Communication from the City Plan and Zoning Commission advising that at their meeting held October 18, 2012, the following action was taken regarding a request from Conlin Properties, Inc. (purchaser) represented by James Conlin (officer) to rezone property located at 3710 Hubbell Avenue from "C-2" General Retail and Highway Oriented Commercial District and "R1-80" One-Family Residential District to "PUD" Planned Unit Development District.

APPROVAL of Part A) to find the requested rezoning is in conformance with the Des Moines' 2020 Community Character Plan future land use designations of Commercial: Auto-Oriented Small-Scale Strip Development and Medium Density Residential; Part B) to approve the proposed rezoning from "C-2" General Retail and Highway Oriented Commercial District and "R1-80" One-Family Residential District to "PUD" Planned Unit Development District; and Part C) to approve the proposed PUD Conceptual Plan for Hilltop Apartments, subject to the following revisions: (ZON2012-00172)

STAFF RECOMMENDATION TO THE P&Z COMMISSION

CONCEPTUAL PLAN FOR HILLTOP APARTMENTS

SHEET 1 OF 4

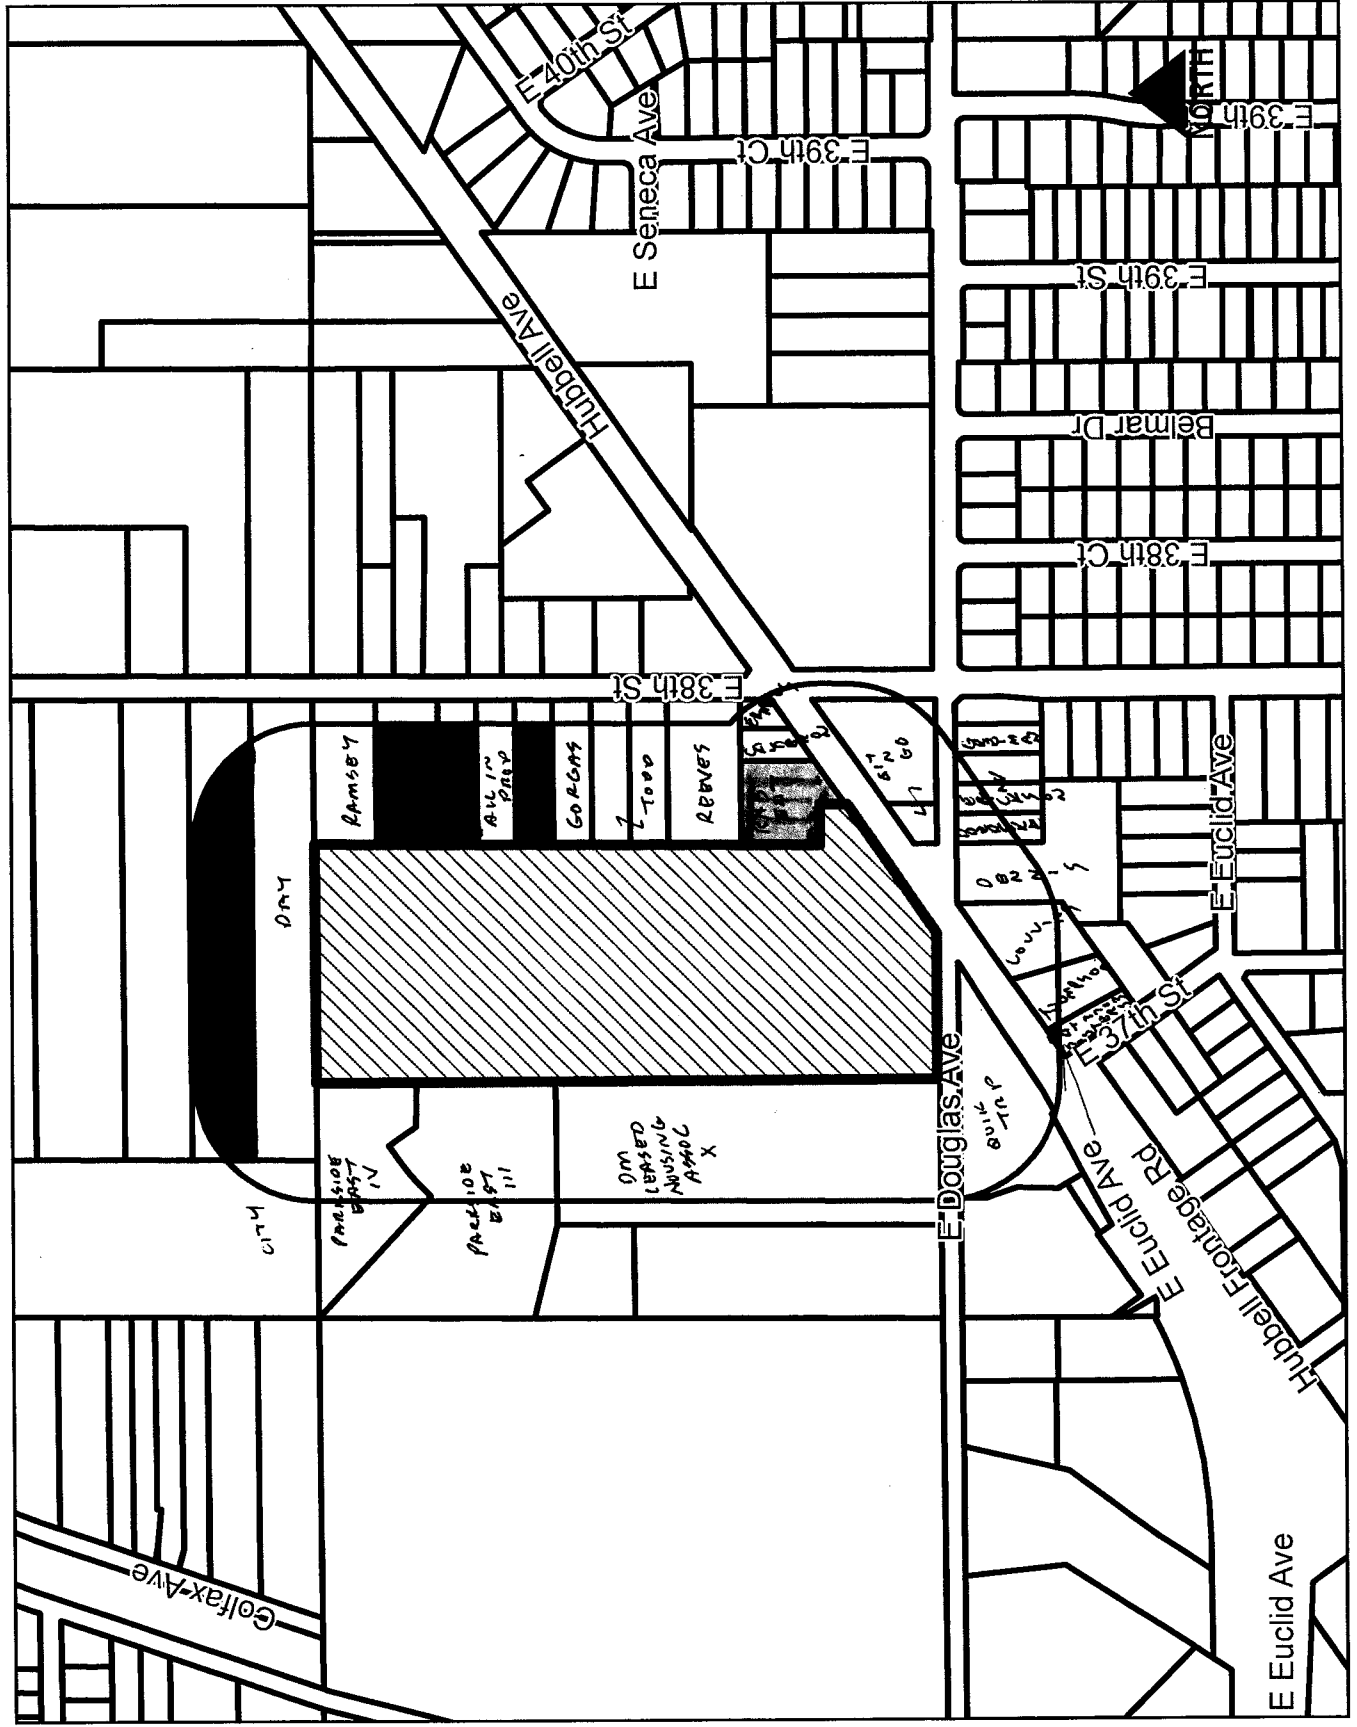
1. The notes regarding the buffer be revised to state the buffers along the north and east property lines will include a 20-foot wide buffer containing a 6-foot tall solid wood fence, at least 4 overstory trees, and a mix of at least 8 additional evergreen, ornamental, or overstory trees.

2. The note regarding the required traffic study shall be clarified to state that the traffic study will include trip generation and distribution estimates for the proposed development, including analysis of the impact on the surrounding street system. The layout of the PUD Conceptual Plan is preliminary only and, based on the findings of the traffic study, driveway locations may be required to be altered, and turn lanes and/or traffic signals may be required. If the Development Plan is significantly different than the PUD Conceptual Plan, the PUD Conceptual Plan may have to be amended.

3. The 30-foot building setback line along Hubbell shall be shifted 15 feet to accommodate the demonstrated 15 feet of future Hubbell Avenue right-of-way.

4. Provision of the following note: In accordance with IFC Section 508.5.1; where a portion of the facility or building hereafter constructed or moved into or within the jurisdiction is more than 400 feet from a hydrant on a fire apparatus access road, as measured by an approved route around the exterior of the facility or building, on-site fire hydrants and mains shall be provided (Exception: R-3, U & sprinklered buildings shall be no more than 600 feet from a hydrant).

solid wood fence and 4 overstory trees and 8 evergreen trees per 100 lineal feet. In this instance, staff believes that given the topography in the area where some of the properties to the east are elevated above the site, it may be more appropriate to provide a mix of additional overstory and ornamental trees in place of the proposed evergreens. Therefore, staff recommends the notes regarding the buffer be revised to state the buffers along the north and east property lines will include a 20-foot wide buffer containing a 6-foot tall solid wood fence, at least 4 overstory trees, and a mix of at least 8 additional evergreen, ornamental, or overstory trees.

The PUD Conceptual Plan provides 15 feet for future Hubbell Avenue right-of-way. It also indicates that sidewalks will be provided throughout the development and along Hubbell Avenue and East Douglas Avenue. (Note: The proposed 30-foot building setback line along Hubbell should be shifted 15 feet to accommodate the demonstrated 15 feet of future Hubbell Avenue right-of-way.)

FRONT ELEVATION
 (36 UNIT MULTIFAMILY BUILDING (30 UNIT BUILDING SIM.)

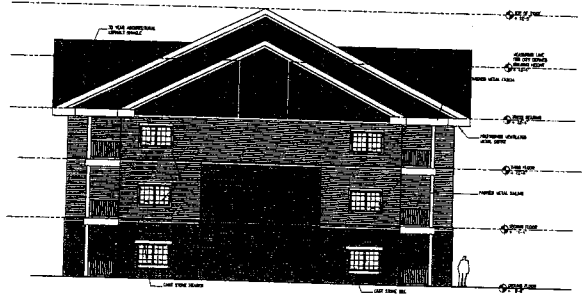
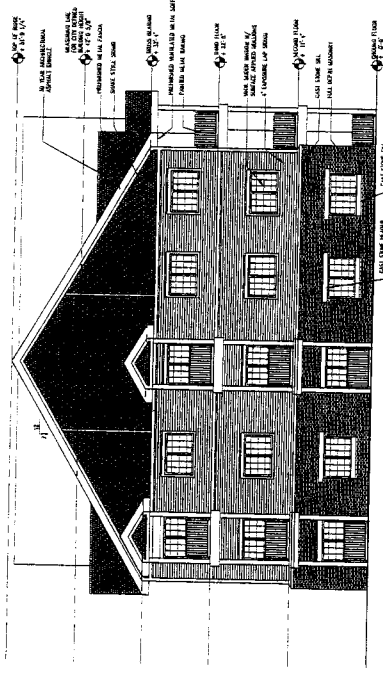
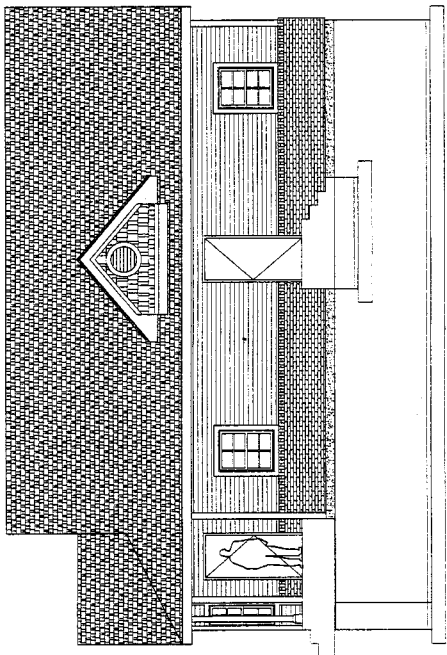
The multiple-family residential buildings also include balconies constructed of treated wood, painted wood, or painted metal. Staff recommends that this note be revised to require all balconies to be constructed of metal materials rather than wood materials.

The submitted PUD Conceptual Plan only includes elevations of the front and side facades of the multiple-family structures. Staff recommends that the PUD Conceptual Plan include the elevations for all facades of the structures to the satisfaction of the Planning Director.

5. The PUD Conceptual Plan shall indicate that vinyl shall not be a permitted material for the proposed horizontal overlap siding.
6. The PUD Conceptual Plan shall indicate that all balconies on the multiple-family residential structures shall be constructed with predominantly metal materials.

7. The PUD Conceptual Plan shall include the elevations for all facades of the multiple-family residential structures to the satisfaction of the Planning Director.
